**STAFF REPORT**  
**DATE: 12/12/2023**  
**WORKSHOP DISCUSSION**

**TO:** City Council  
**FROM:** Nathan Fuerst, AICP, Consulting Planner  
**AGENDA ITEM:** **Comprehensive Plan Amendment Sketch Review – Kramer Lake Property Proposal by Tamarack Land Development**  
**REVIEWED BY:** Jenni Faulkner, Senior Consulting Planner

**KRAMER LAKE OVERLOOK  
MIXED-USE DEVELOPMENT  
LAKE ELMO, MN  
COMPREHENSIVE PLAN AMENDMENT**

**DATE:** November 4, 2022  
**TO:** Dan Willenbring, Tamarack Land Development  
**FROM:** Molly Just, Planning Director  
**RE** Subdivision Sketch Plan Application for PIDs 35.029.21.43.0001 and 34.029.21.44.0012

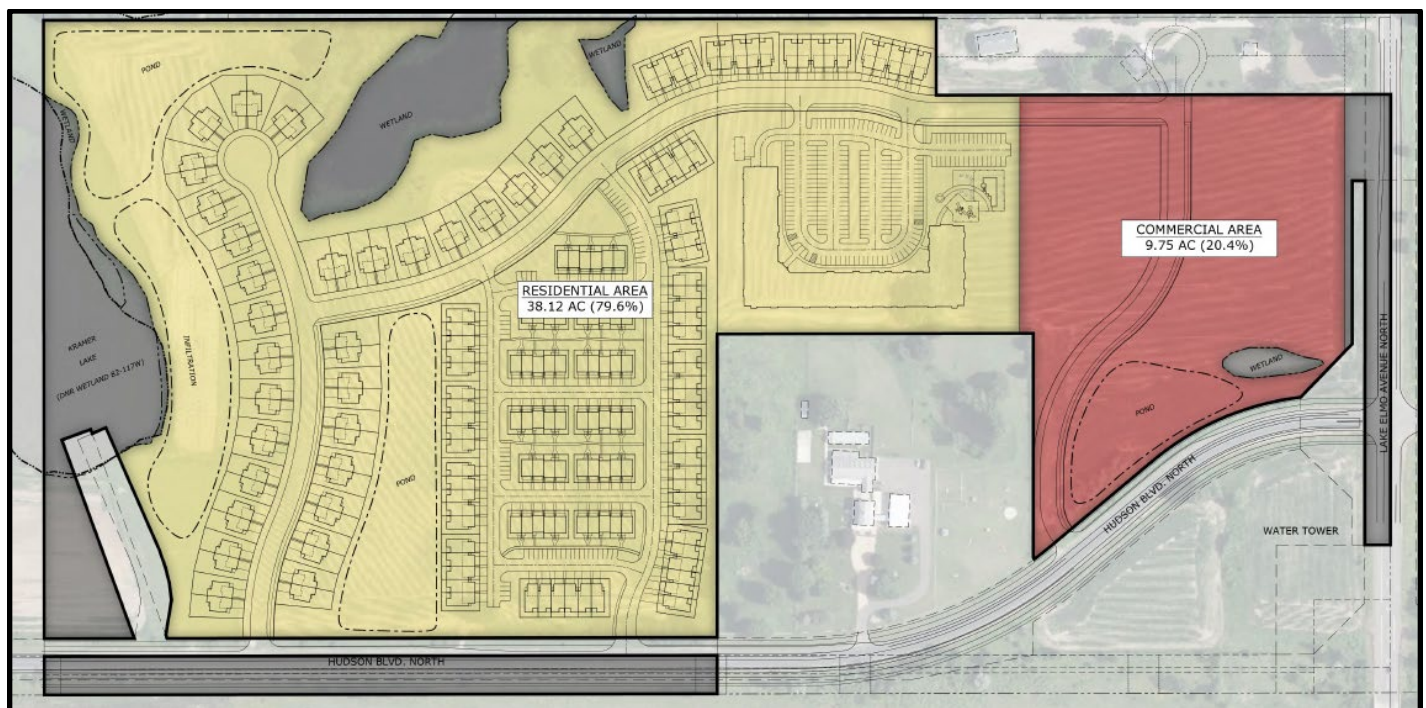
The Application depicts approximately 10 acres for commercial development at the intersection of Hudson Boulevard and Lake Elmo Avenue, with access from Hudson Boulevard. The project then transitions to multifamily housing, then to single family attached and then to twin home units closer to the wetland and Kramer Lake. This transition of density is appropriate. Access to the proposed development is constrained by the 10024 Hudson Boulevard parcel. It would benefit the project and the City to have a continuous Hudson Boulevard improvement along this frontage.

The Application depicts 362 residential units (171 multifamily units, 60 twin home units and 131 attached single family (townhome) units). An Environmental Assessment Worksheet consistent with Minnesota Rules, Chapter 4410 must be prepared for projects meeting the thresholds of [Minnesota Rules, part 4410.4300, Subparts 19a, 20a, 25, 27, 28, 29, and 36a.](#)

The Application consists of two parcels but not all of the eastern parcel is depicted. The parcel will have to be split or fully depicted with Preliminary Plat. With this process, the remnant ROW/parcel areas along Hudson Boulevard and Lake Elmo Avenue must be cleaned up.

A Preliminary Plat/PUD based on this concept must address the guidance provided in this memo. The updates or changes should be addressed point by point in a memo and be clearly depicted on plans. A substantive change to the concept may trigger the need for a new concept review.
